**DEVIATION REQUEST
AND DECISION FORM**

Project Name :	Table Rock Homestead
Schedule No.(s) :	5100000012, 5100000026
Legal Description :	See Attached

A deviation from the standards of or in Section **2.3.8.A, Figure 2-31** of the Engineering Criteria Manual (ECM) is requested.

SUNSET PRAIRIE LANE
 FROM STA 00+00.00
 TO STA 14+11.42
 TABLE ROCK HOMESTEADS
C1.4
 SHEET 4 OF 5

CUL-DE-SAC BULB PROFILE
 SCALE 1" = 50'

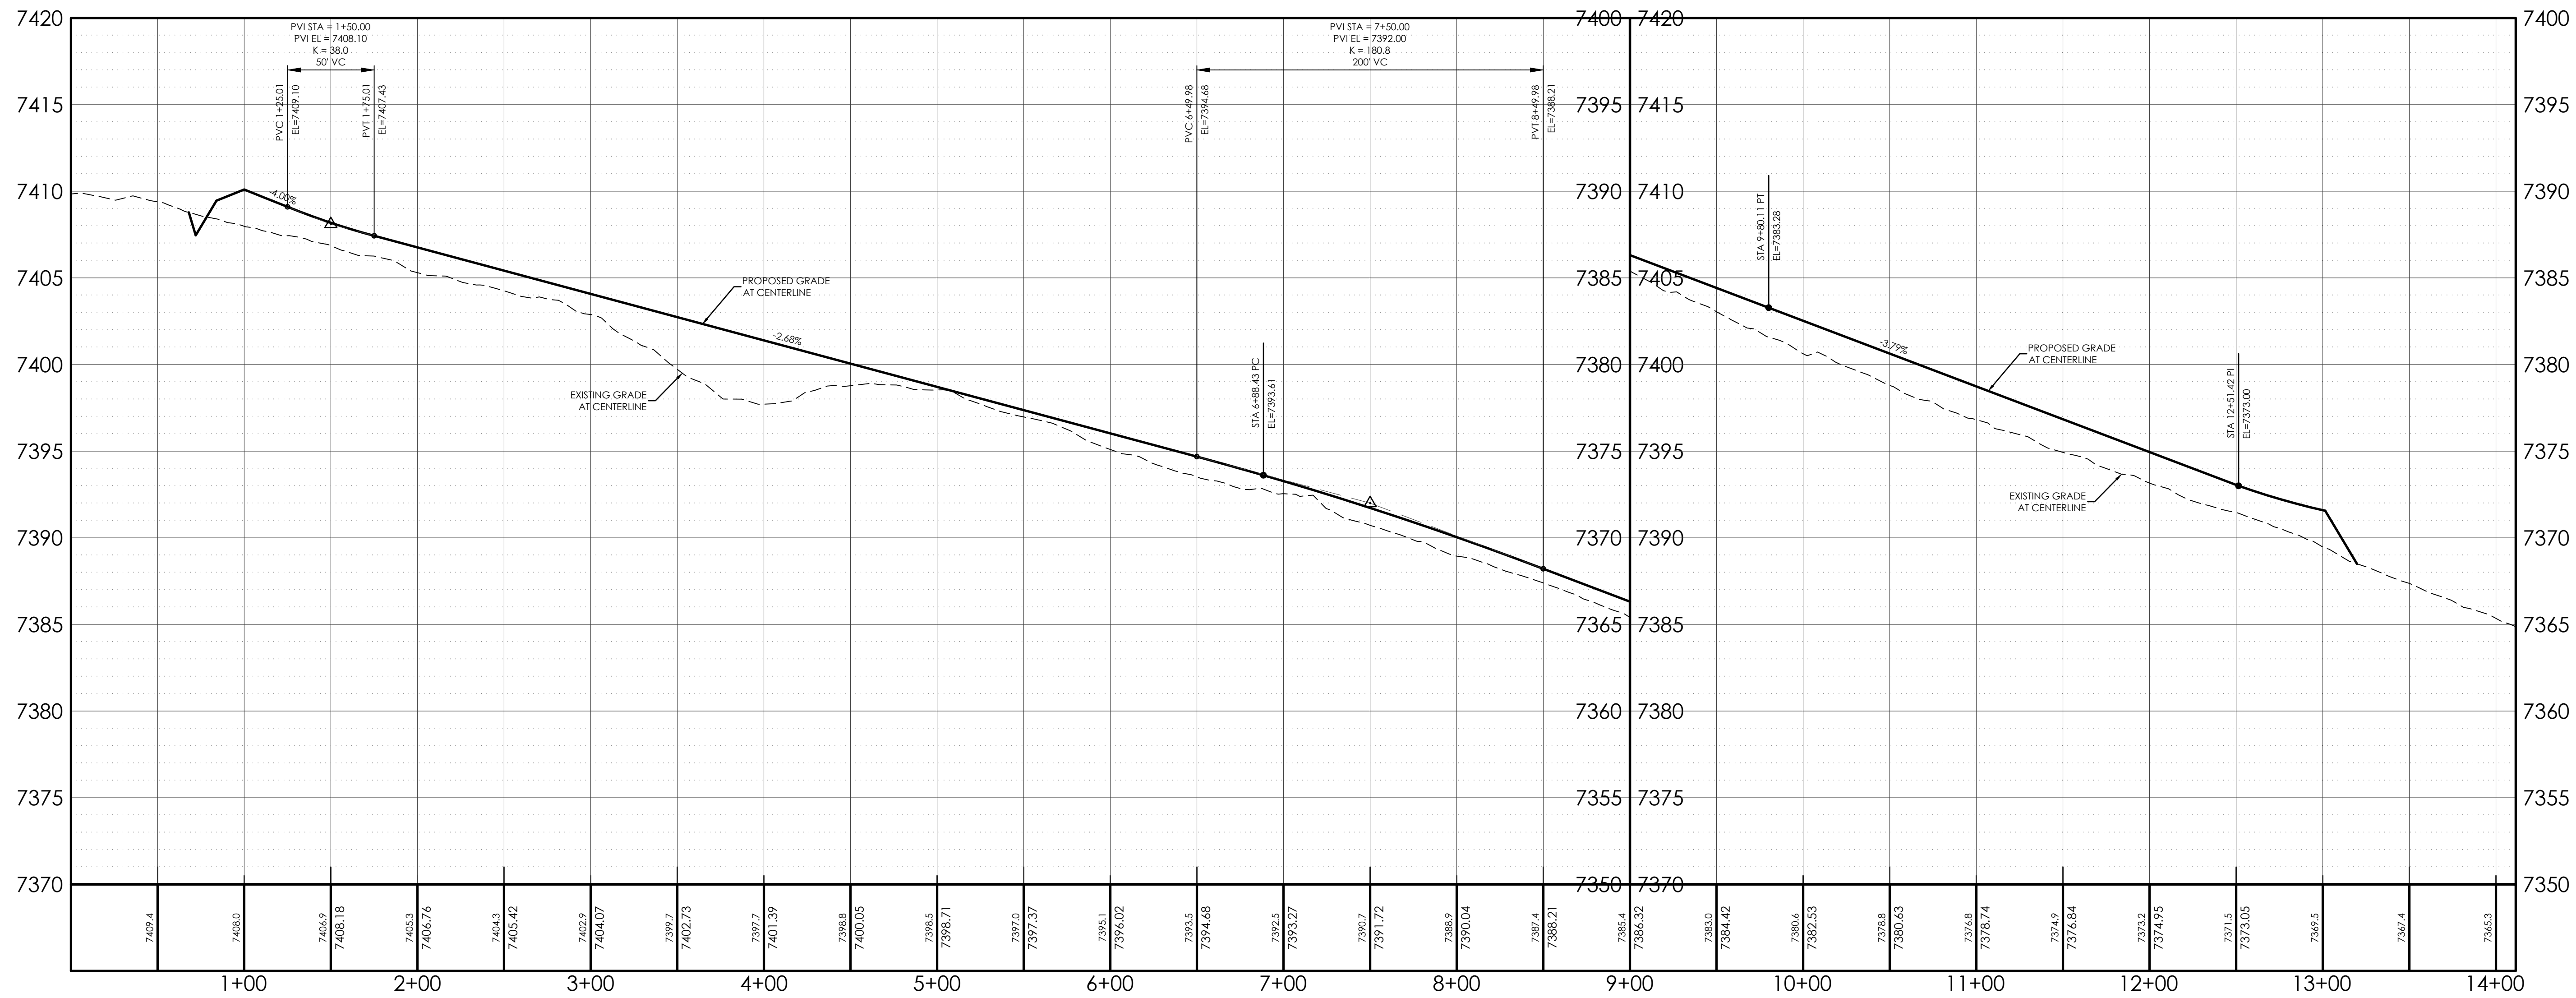
ECM Section 2.3.8.A, Figure 2-31 indicates 2.0% maximum grade in rural cul-de-sacs, beginning at the cul-de-sac entrance and extending in all directions from the radius point.

There is significant elevation relief throughout the Table Rock Homesteads site. The county requires the public roadway to extend to the east property line for potential future access to the adjacent east property. This has been provided on the proposed plat and construction documents with extension of Sunset Prairie Lane to the east property line which terminates at the property line with a cul-de-sac. However, the existing grade at the east cul-de-sac location exceeds 4%. If the ECM Criteria is applied, the east end of the cul-de-sac is excessively elevated above the existing grade creating tall fill slope on the east end of the cul-de-sac. Future extension of the roadway will also needlessly require significant filling making use of the road for future lot access difficult. Note that the proposed rural local roadway is to be gravel surfaced and the normal cross section will have 4% lateral cross slopes on each side of the centerline crown in compliance with El Paso County Standard Drawing SD 2-10.

The proposed alternative is to allow 3% slopes within the gravel cul-de-sac to maintain reasonable grades adjacent to the proposed roadway and enable future extension of the roadway to the east without excessive fill required at the east site boundary. The urban cul-de-sac standard allows 3% cul-de-sac according to ECM Section 2.3.8.A, Figure 2-31. Additionally, the proposed roadway is rural local gravel which is required to have 4% cross slopes on each side of the road centerline according to El Paso County Standard Drawing SD 2-10. It would be inconsistent with SD 2-10 to limit the cul-de-sac grades to 2%.

The natural existing grade at the proposed cul-de-sac exceeds 4% and falls away from the site. Adhering to the 2% standard would create excessive slopes on the east side, making driveway connection difficult and forcing excessive fill slopes upon future extension of the roadway to the east. Requested deviation to increase the slopes in the cul-de-sac will create a hazardous condition and the slopes will still be less than the allowed cross slopes on the gravel roadway present throughout the rest of the site.
